1970 March 2

Mr. L. M. Burstein
FAA RD-630
Washington, D. C. 20509

The proposed American National Standard Keyboards I shall refer to as the pANS Keyboards. In view of the negative ballots at the ANSI X4 Committee, the pANS is now under review by the ANSI Subcommittee X4-A9. In such review situations, the potential for changing the pANS exists. In order to assess the "changeability" of the pANS, it is worthwhile to review the history.

FIGURE 1: HARD CORE SET

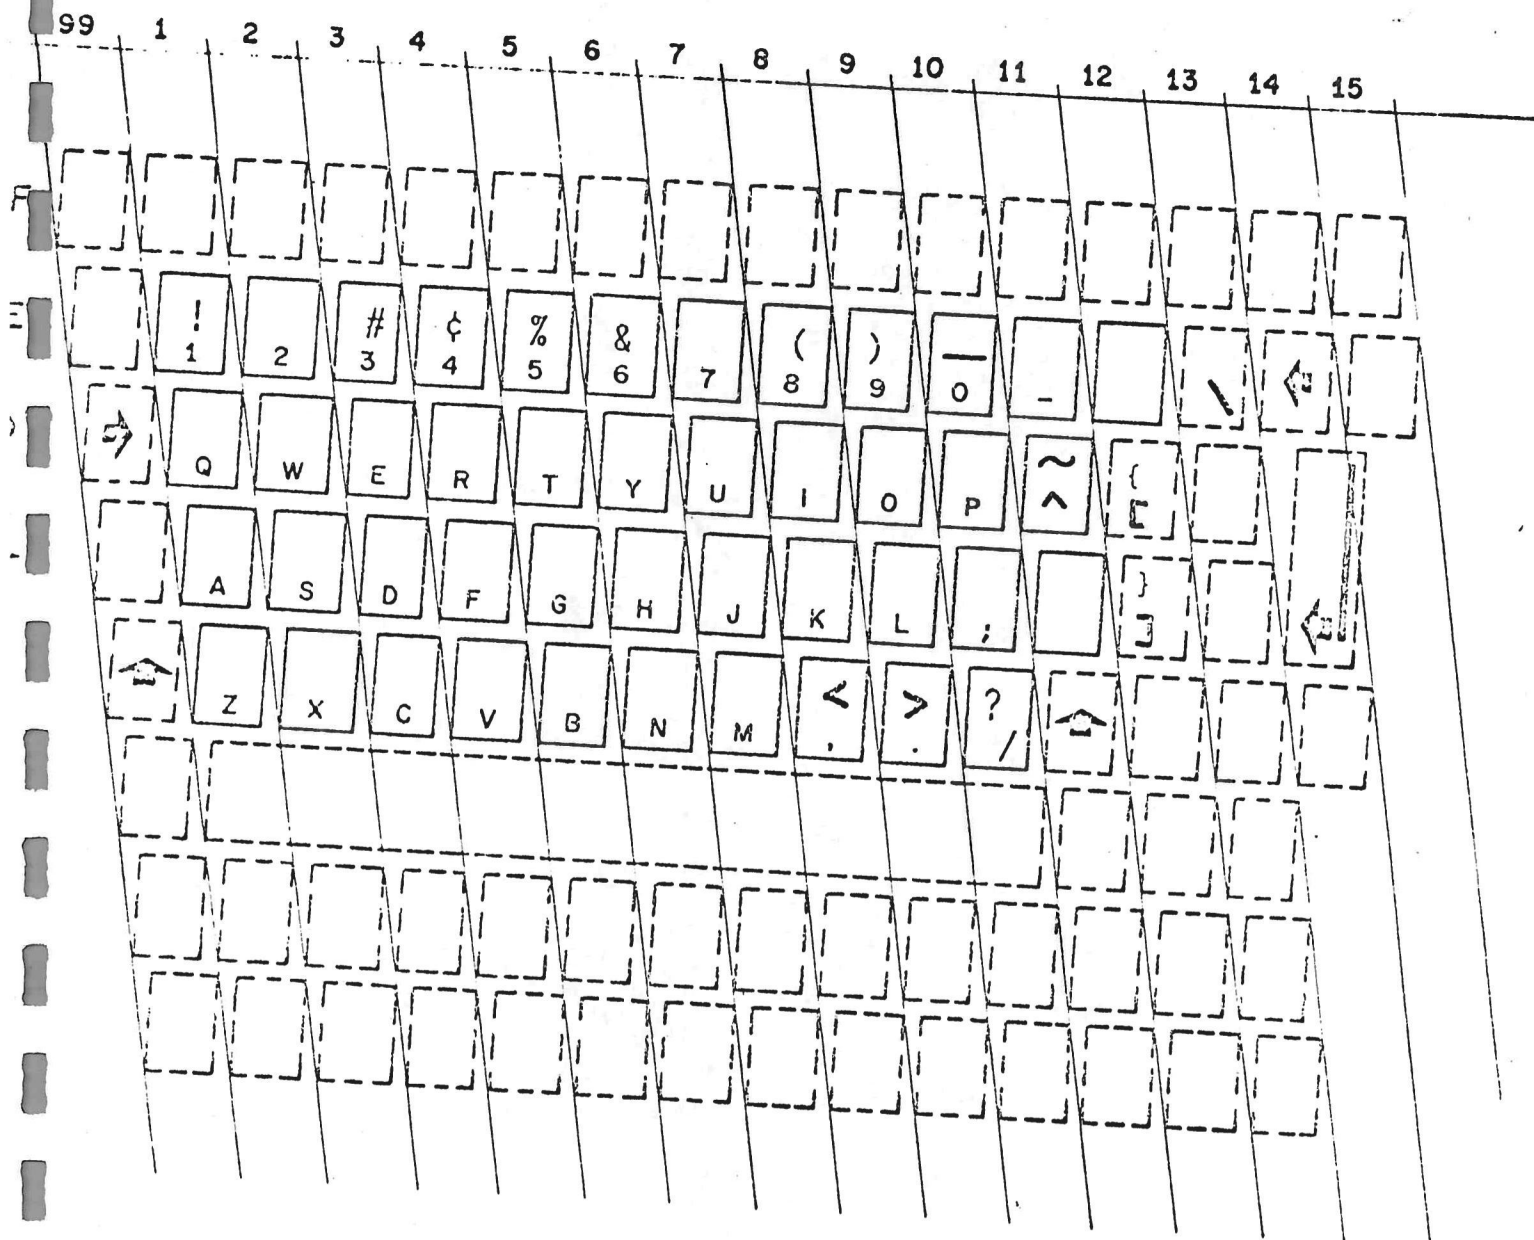
The Hard Core Set is shown on Figure 1.

It is unfortunate that the ~ ^ graphics are not on the same key in both layouts, since there seems to be no reason why they should not be.

FIGURE 2: BIT-PAIRED, (INCOMPLETE)

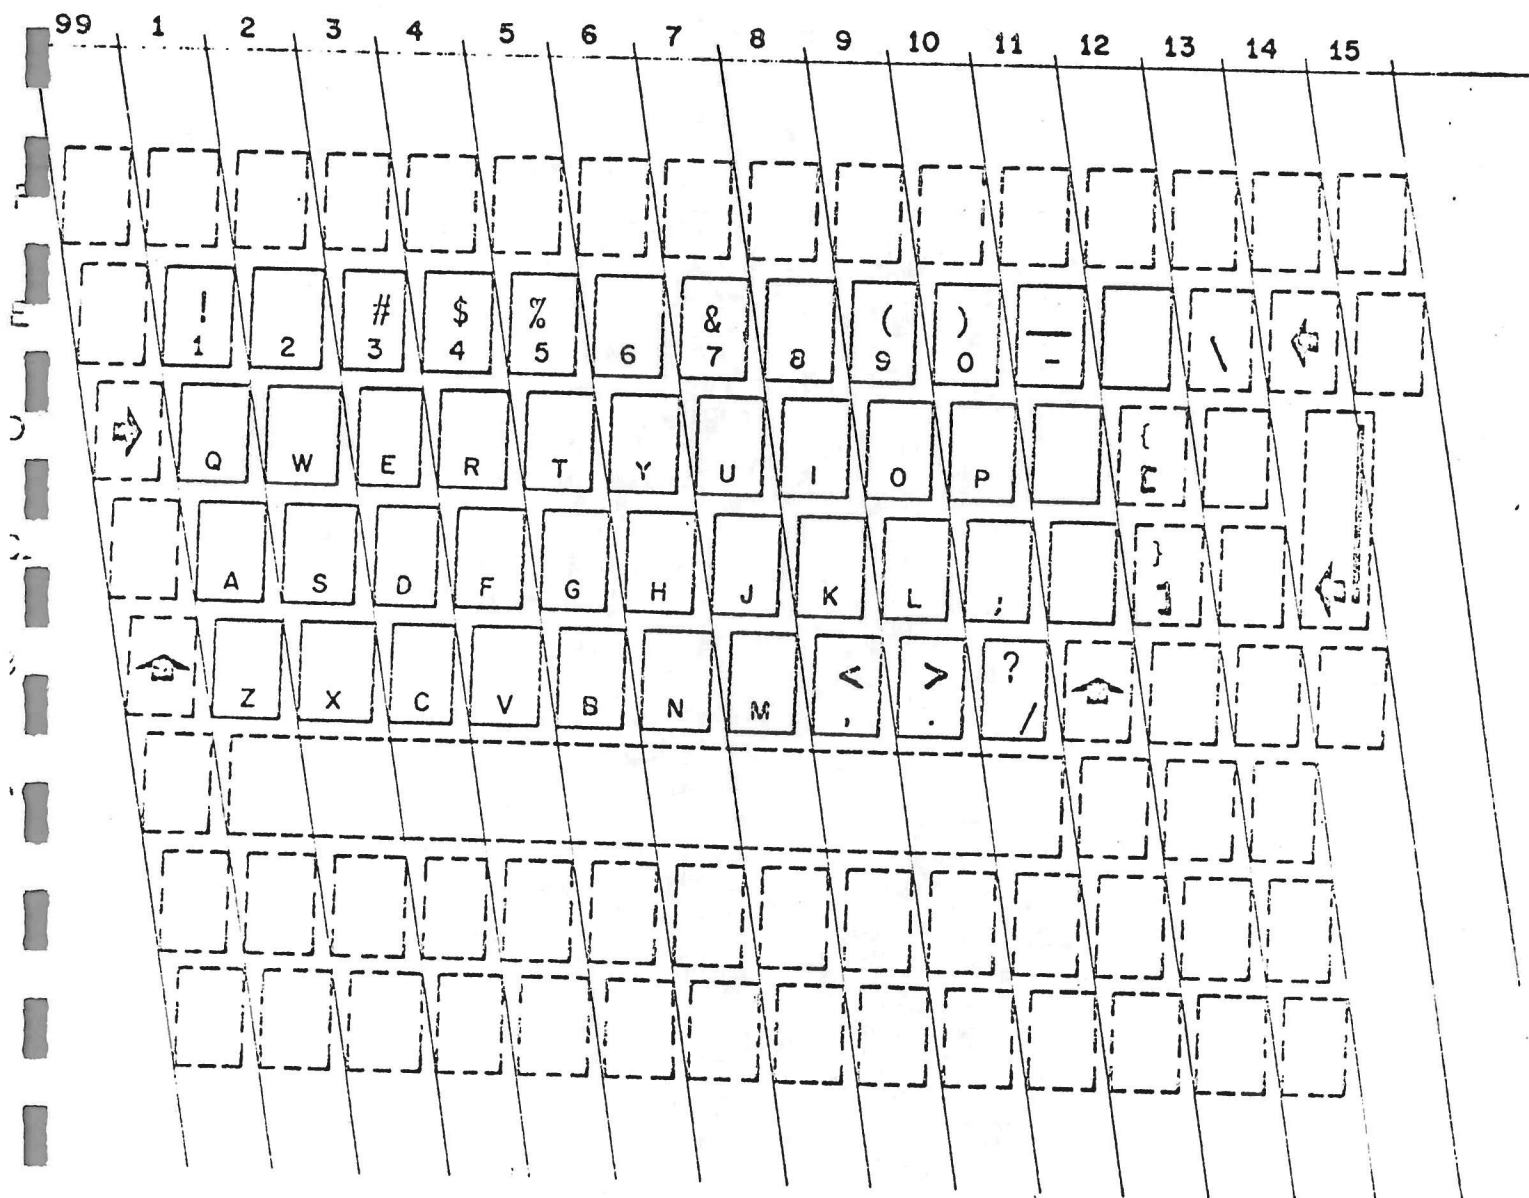
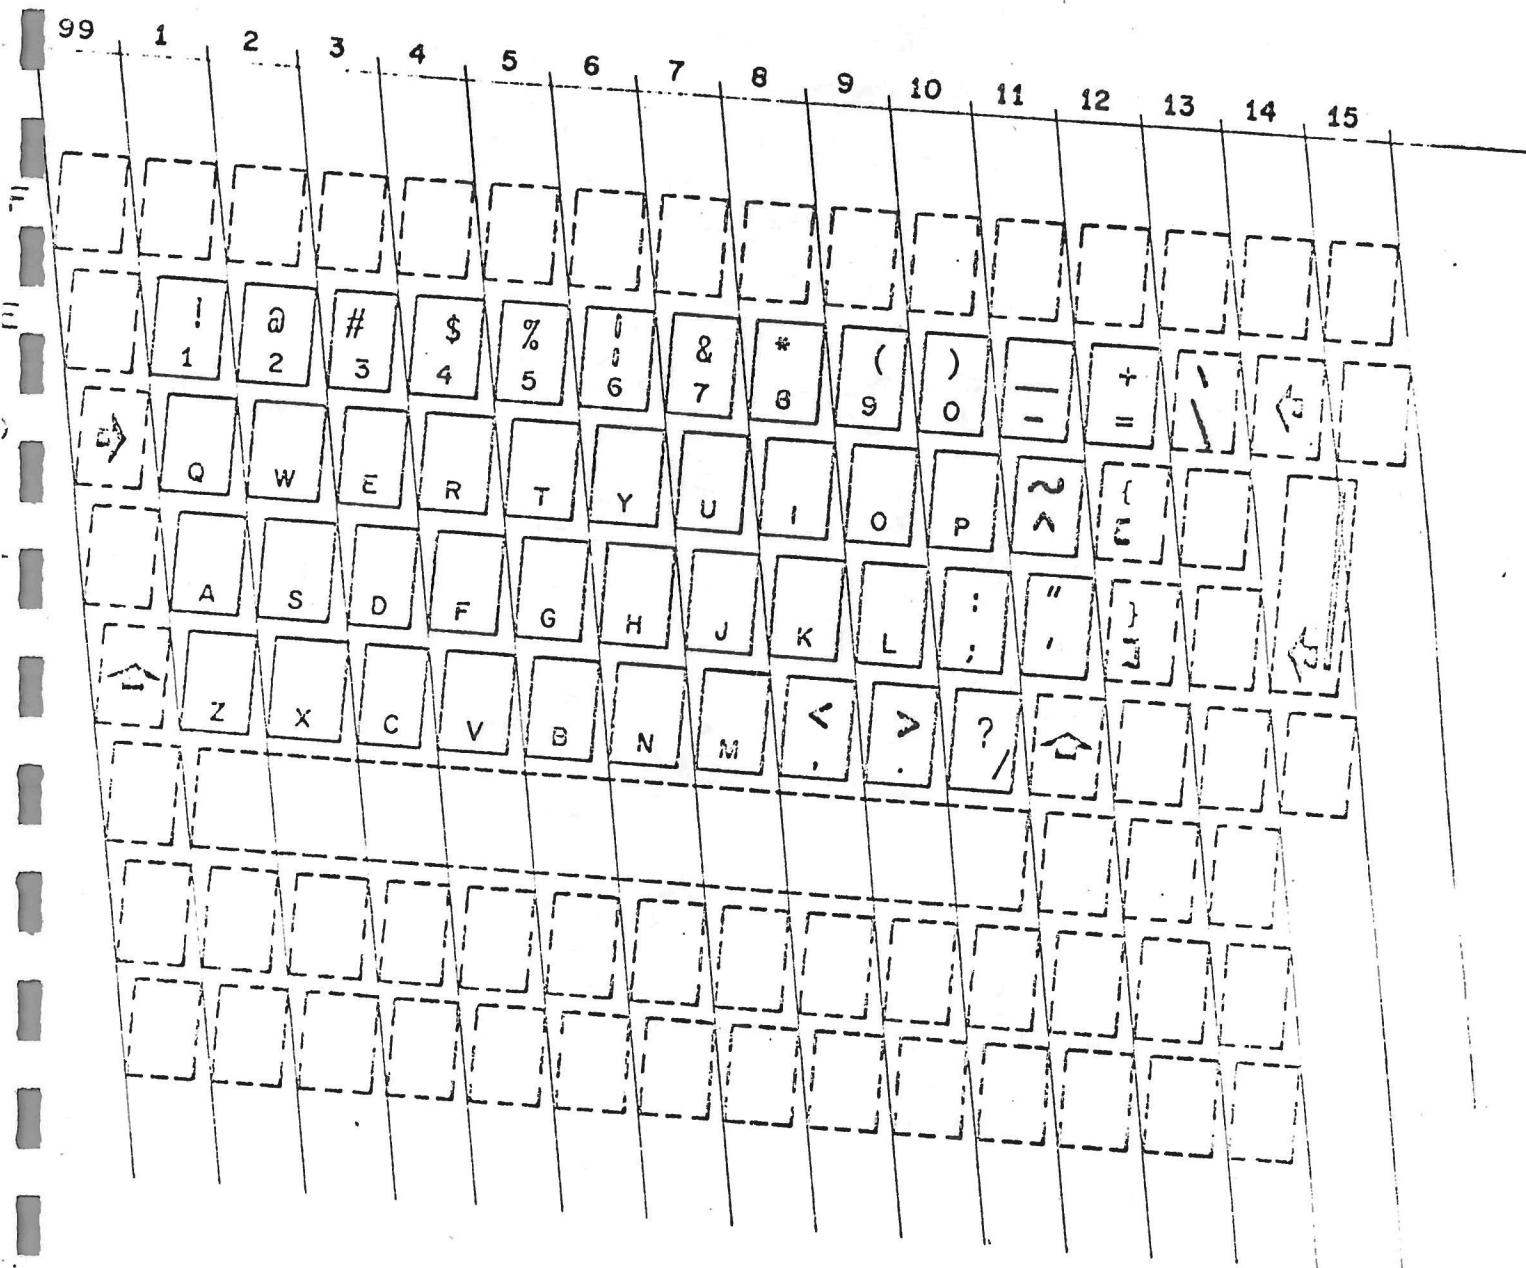
We start with Figure 2, the incomplete bit-paired layout, and complete it according to typewriter pairing, giving Figure 4, Compromise 1. Then we start with Figure 3, the incomplete typewriter-paired layout, and complete it according to bit-pairing, giving Figure 6, Compromise 2. For comparison purposes, Figure 5 shows the Typewriter-Paired Layout, and Figure 7 shows the Bit-Paired Layout.

FIGURE 5: TYPEWRITER-PAIRED LAYOUT

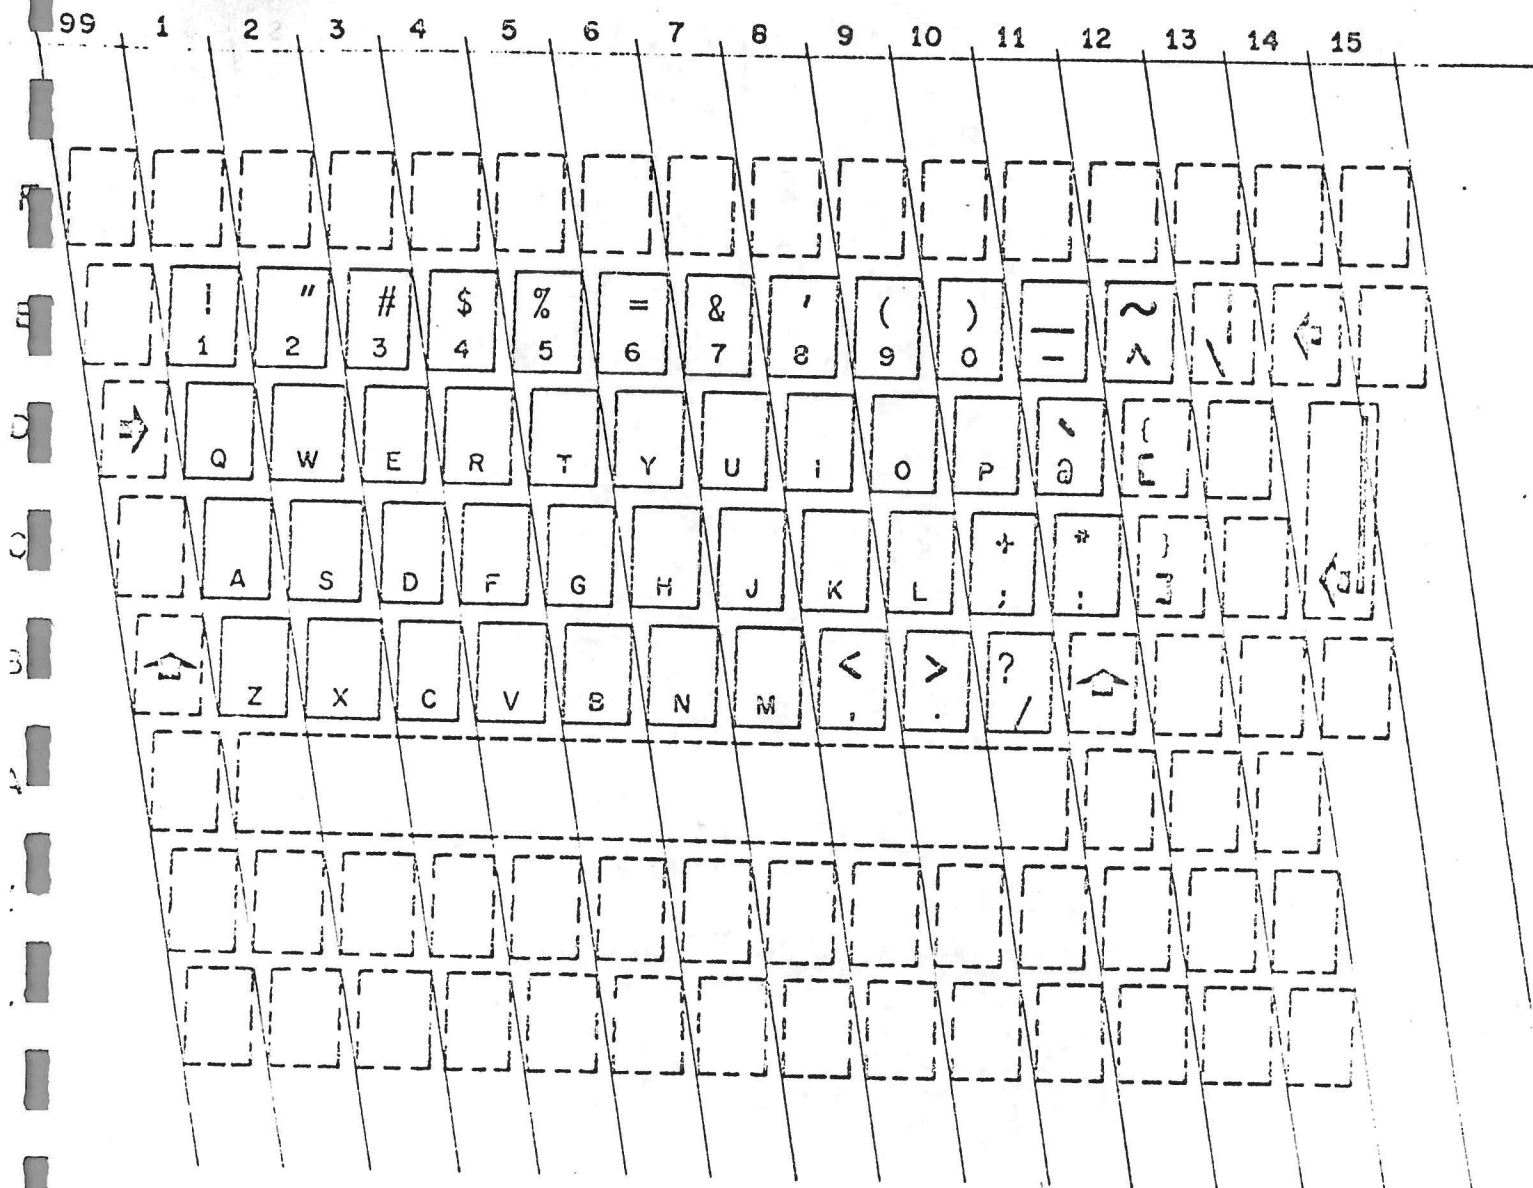
We now compare Figures 4 and 5, and compare Figures 6 and 7.

Given that we cannot persuade the protagonists to give up on the basic dichotomy on left parenthesis, right parenthesis, underscore, so that we would still have to live with two standard keyboard layouts, would the bit-pairing enthusiasts accept Compromise 1 to replace the Bit-Paired Layout of Figure 7, or alternatively, would the typewriter-pairing enthusiasts accept Compromise 2 to replace the Typewriter-Paired Layout of Figure 5?

For the typewriter paired enthusiasts, the fundamental criterion is that as many as possible of the graphics be typewriter-paired. So they would never (I believe) accept Compromise 2, which has many non-typewriter paired keys.

FIGURE 6: COMPROMISE #2

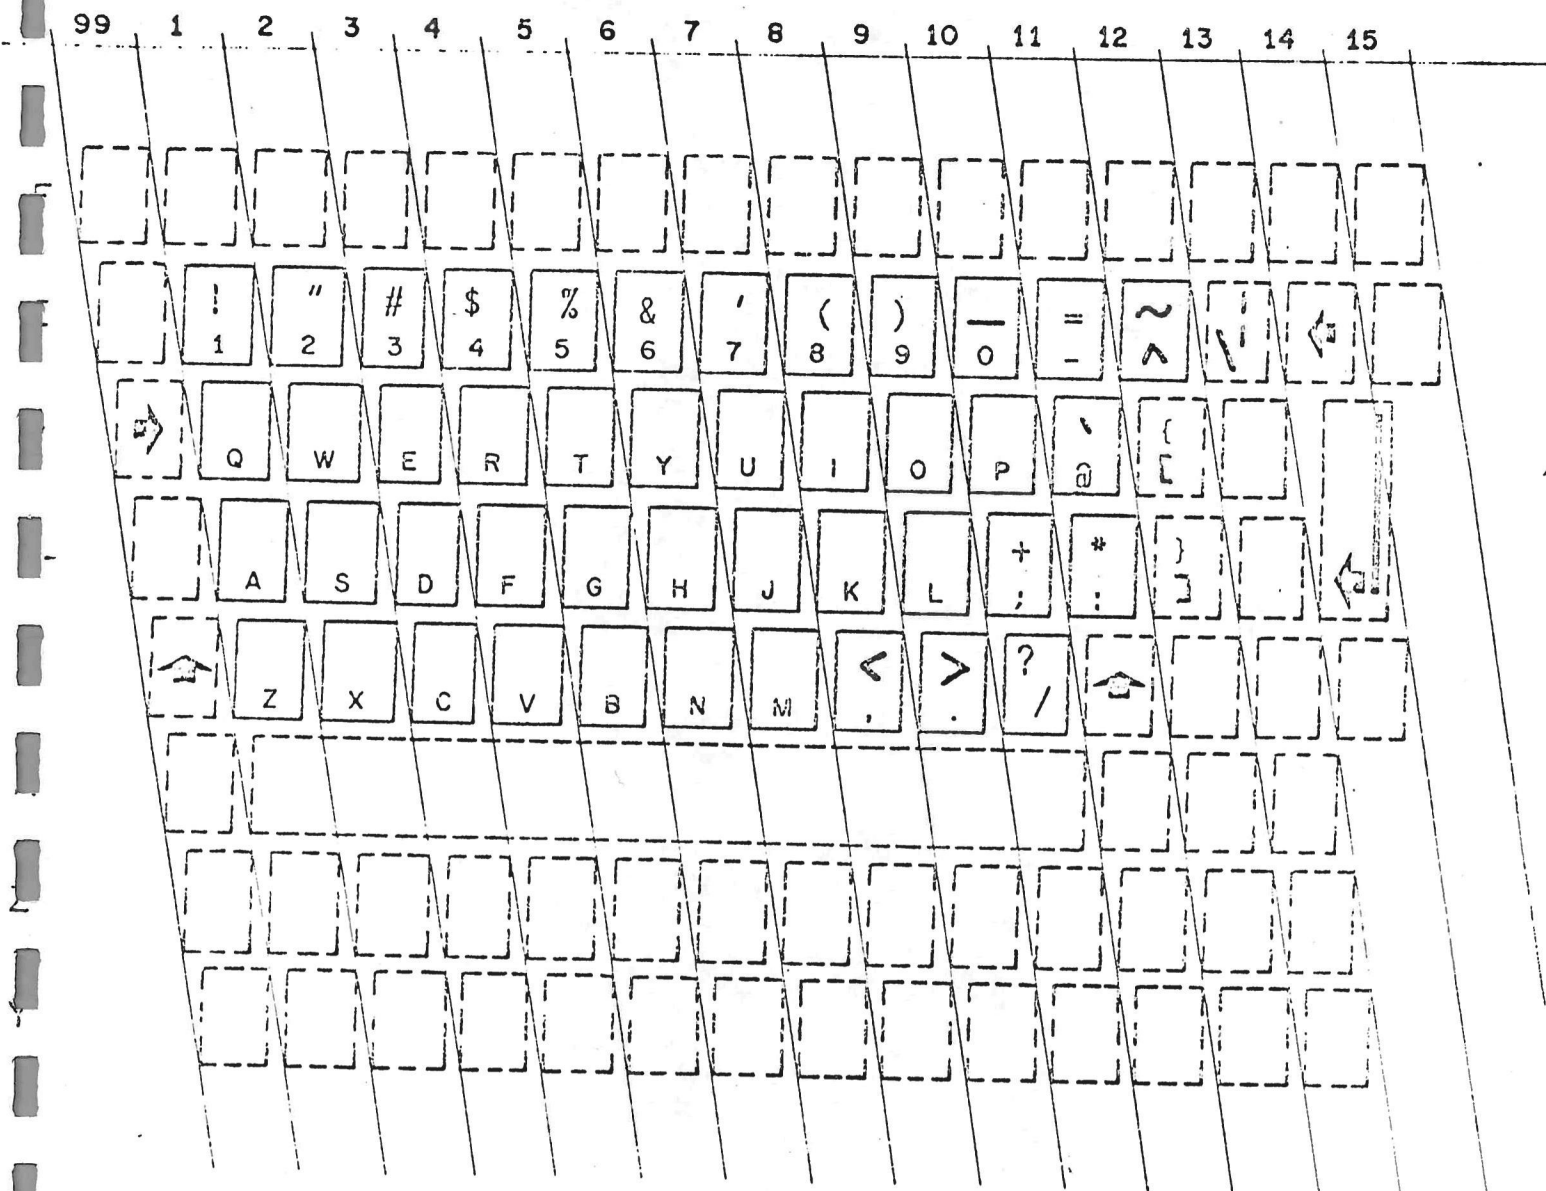
We see that we have, for both Compromise 1 and 2, increased the agreement from 79 to 88 graphics.
